# **MONITORING YEAR 5 ANNUAL REPORT**

## **AGONY ACRES MITIGATION SITE**

RE: Monitoring Year 5 Report for Agony Acres Mitigation Site (95716)  
Cape Fear River Basin (03030002)  
Guilford County, North Carolina  
Contract No. 004949

We have reviewed the comments on the Monitoring Year 5 Report for the above referenced project dated November 7, 2019 and have revised the report based on these comments. The revised documents are submitted with this letter. Below are responses to each of your comments. For your convenience, the comments are reprinted with our response in italics.

2018 Aerial Photography

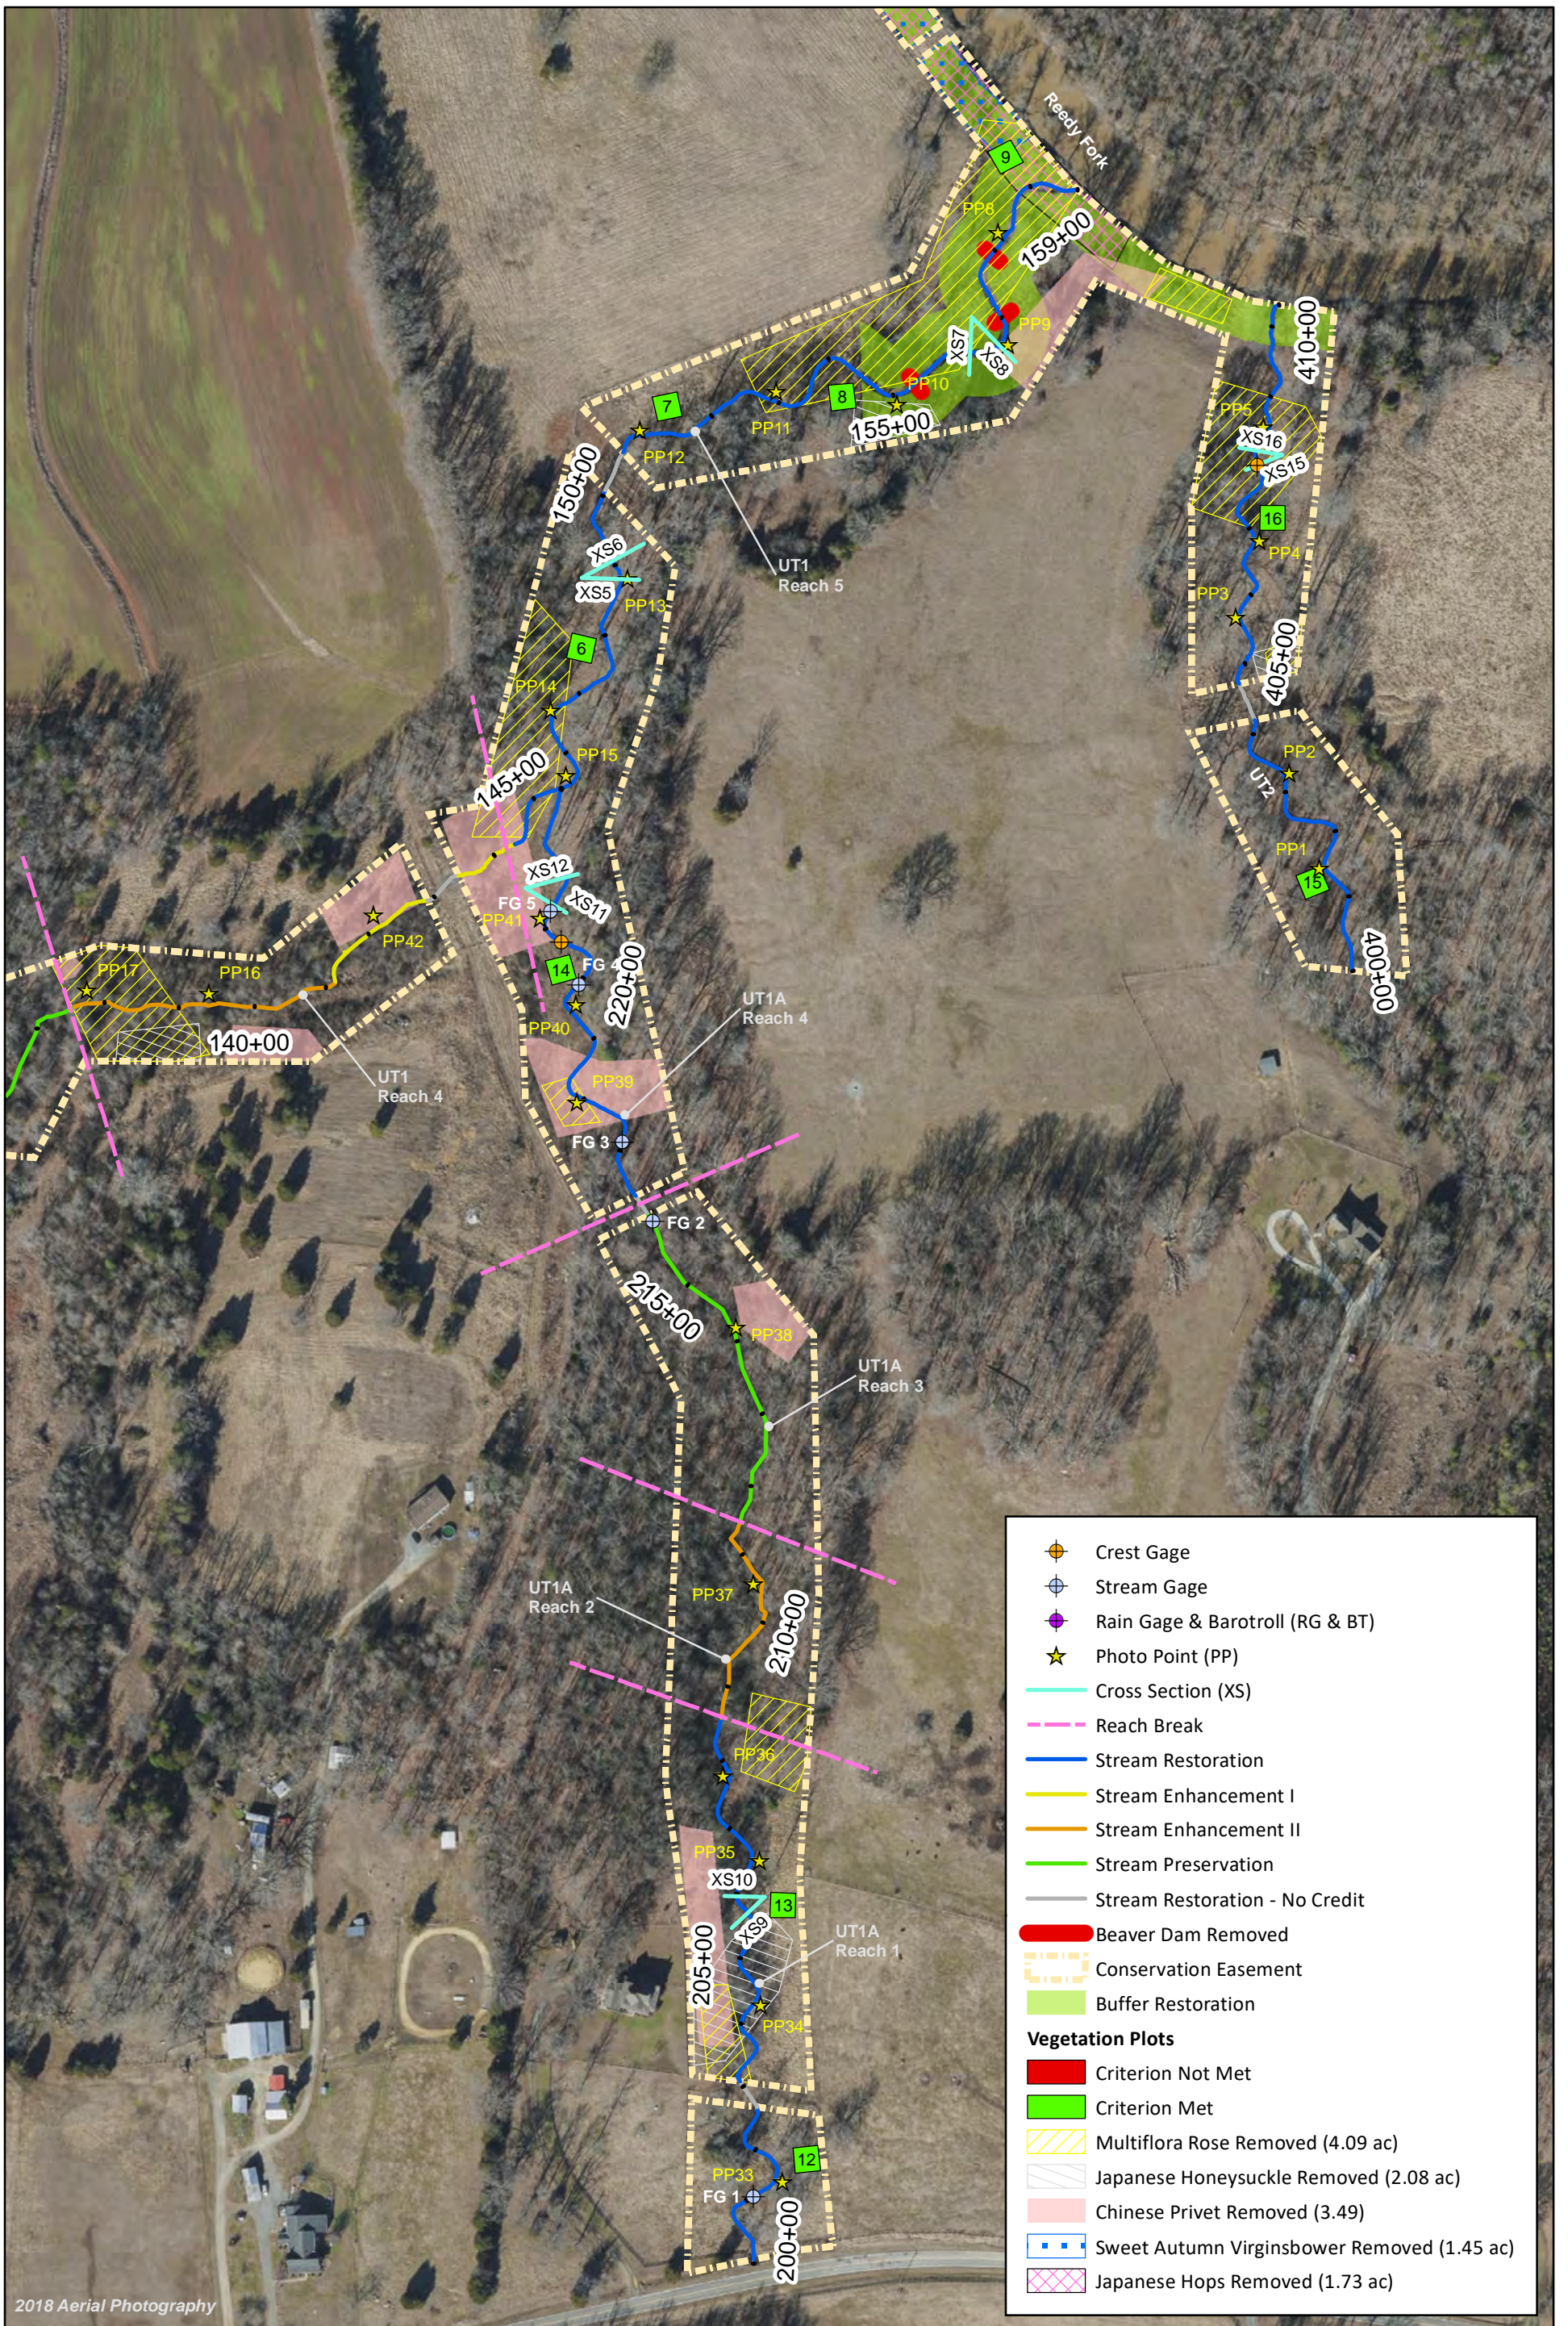
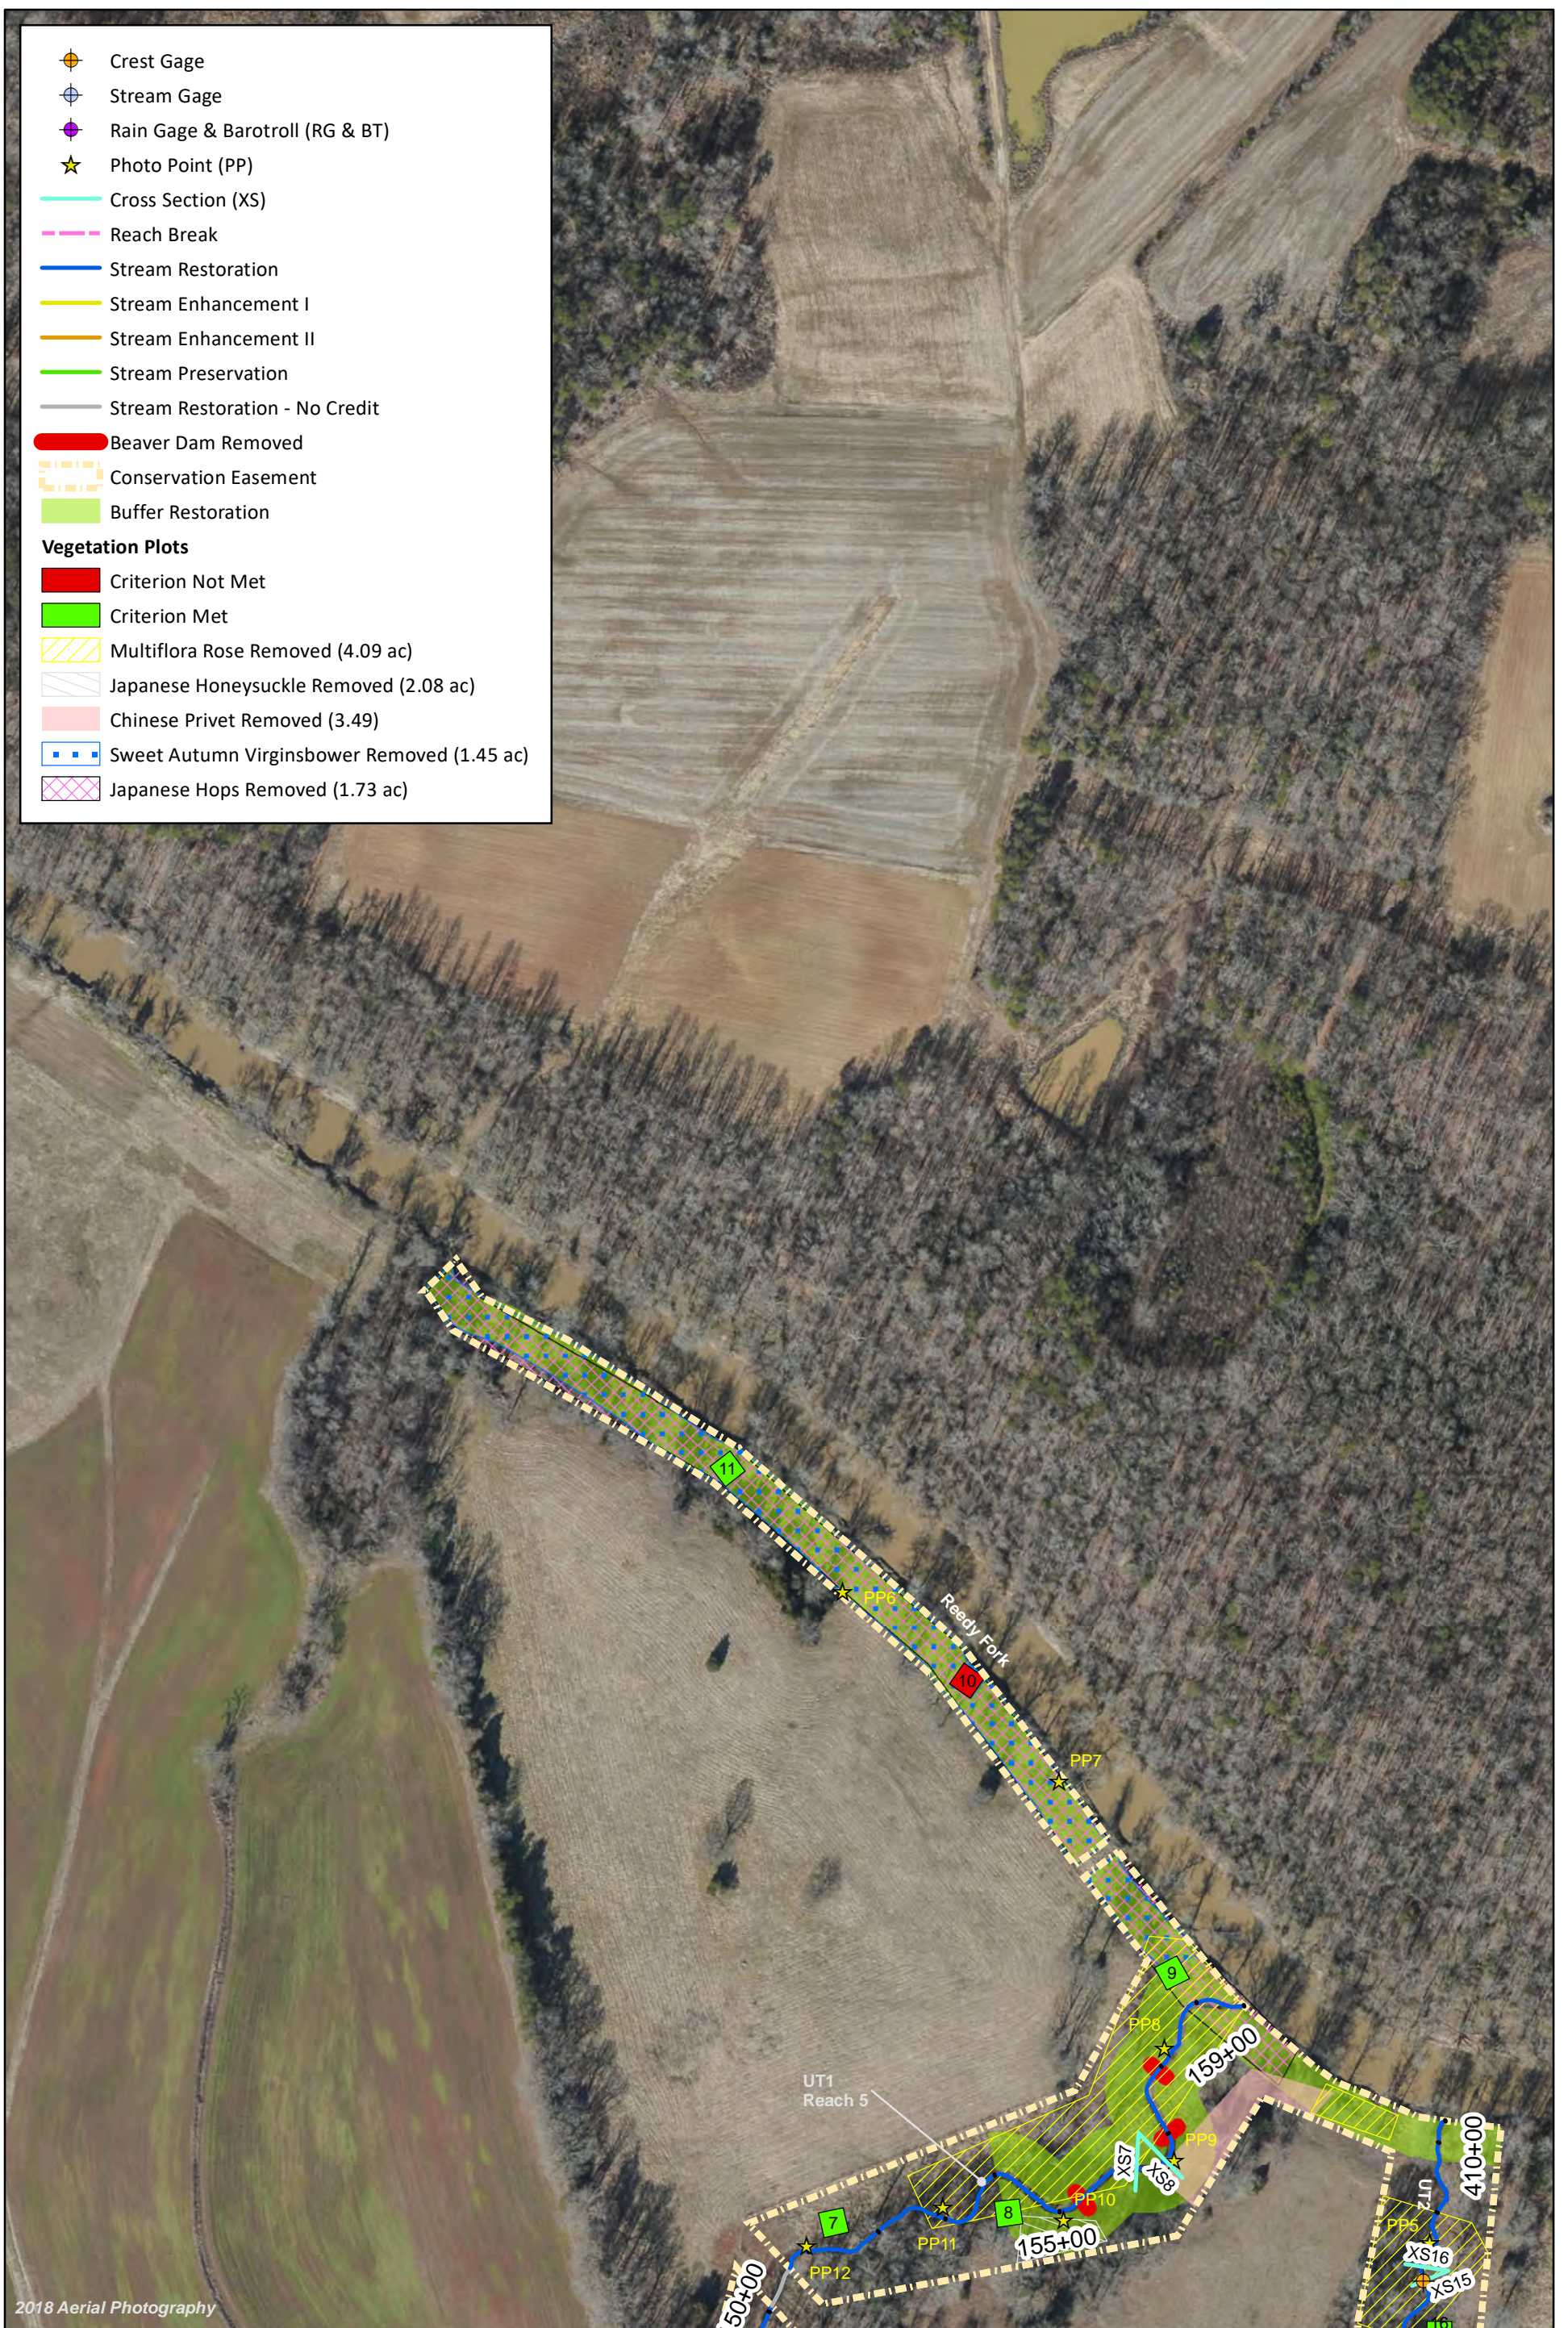
The last sentence has been reworded to avoid misinterpretation.
3. Section 1.2.5  
Per IRT comments during the site visit on Nov. 6, please include a brief discussion of UT1A flow gauge data here.  
*A discussion of the UT1A flow gauge data has been added.*
4. Appendix 2  
Figure 3.2 – Please add UT1A flow gauges to CCPV.  
*UT1A flow gauges have been added to the CCPV.*
